YAMAHA

PARTS CATALOGUE

GOLF CAR

TECHNICAL BULLETIN

G2-A, G2-E Crate Handling

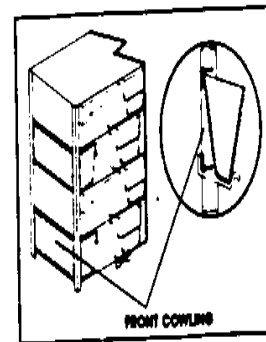
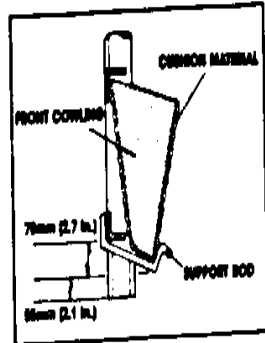
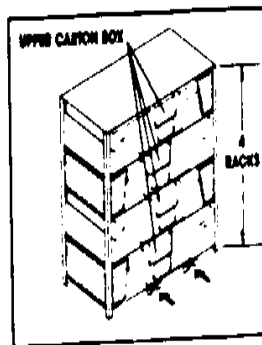
The following information is presented in an effort to eliminate damage to the front cowl (and other golf car body parts) during shipping, handling and uncrating. Taking a little time up front to properly handle golf car crates will save a lot more time and money in the long run.

1. Do not lift the crate by the ends. The packed position of the front cowl cover allows its edge to protrude below the bottom bar on the crate. This being the case, any attempt to pick up the crate by the end will damage the cowl cover.

2. Do not push the crates at the ends. The front cowl cover is packed close to the thin bottom bar of the end of the crate. Therefore, any attempt to push the crate at that end will likely damage the cover.

4. Lift the car from the crate carefully. The G2 is more difficult to lift from the crate because there is less clearance between the car and the crates and because the top car is higher off the ground.

If you use straps to pick up the car, be sure to position them so that no stress is placed on any plastic body panel components.

If you use a fork lift to pick up the car, be extremely careful to position the forks properly to avoid damage to either the car, you are lifting, or the one under it.

G2-E5 DIRECTIONAL SWITCH KIT INSTALLATION

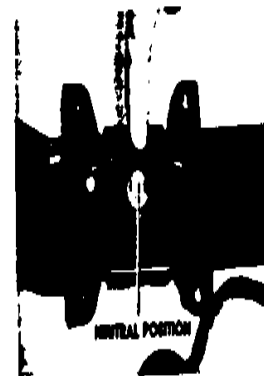
On affected units, the forward/reverse shift lever may become loose. The lever may rattle or vibrate noisily. This condition is a result of excessive clearance between the directional switch cam plate and control shaft roll pin. This condition causes accelerated wear on the cam and the eventual malfunction of the directional switch.

The replacement switch kit will hold the control shaft roll pin in place more firmly.

9. Continue to grasp the assembly components firmly and install the new cam plate and new directional control shaft.

NOTE: Align the keyways grooved into the control shaft with the matching keys on the metal plate (contact side) and then push the shaft through the assembly. Also, the control shaft roll pin must be put into the "FORWARD" position cam slot.

10. Install the new spring, old washer, and new cotter pin onto the shaft.

11. Split and bend the new cotter pin perpendicular to the shaft so the pin will not interfere with the splined lever collar.

G2-A; G2-E STEERING SQUEAK

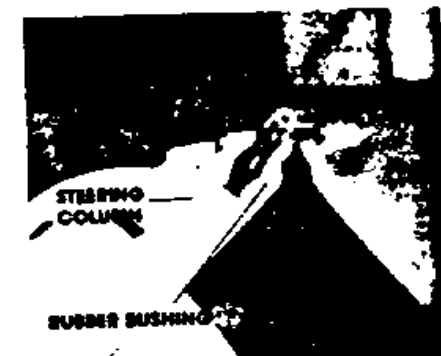
Squeaking sounds can occur when turning the steering wheel of an affected unit. This condition is a result of the lack of grease on the rubber bushing located in the steering column. To correct this condition, follow the service procedures set forth in this bulletin.

1. Remove the scorecard holder.
2. Loosen the nut that holds the steering wheel to the tapered shaft inside the steering column about three turns.

3. Pop the steering wheel loose from the tapered shaft by grasping both sides of the steering wheel (near the cross bars) and rocking the wheel from side to side while pulling outward. The wheel should pop off the shaft but still be kept from coming completely off the steering column by the nut.

4. Remove the nut and steering wheel and look for the "high spots" on the rubber bushing which indicate the location of the spacing ribs on the bushing.

5. Remove the rubber bushing by lifting the thin collar and inserting a blade screwdriver between the ribs gently prying upward. Repeat this procedure on the opposite side of the bushing until it is removed.

G2-E IMPROVED RIDE QUALITY

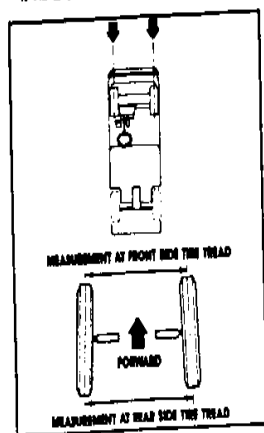
Some of the G2-Es were sent from the factory with incorrect toe-in. Due to suspension design, toe-in adjustment has a direct effect on shock absorber travel. This adjustment procedure increases the travel and improves the ride.

4. Loosen the two adjustment locknuts on the ends of the left and right tie rods. Left side locknuts are left-hand thread and are loosened by turning them clockwise.
5. Adjust each tie-rod equally until the toe-in is correct.
6. Tighten the locknuts and torque them to 35 ft-lb (4.8m-tq).
7. Test drive to confirm proper operation.
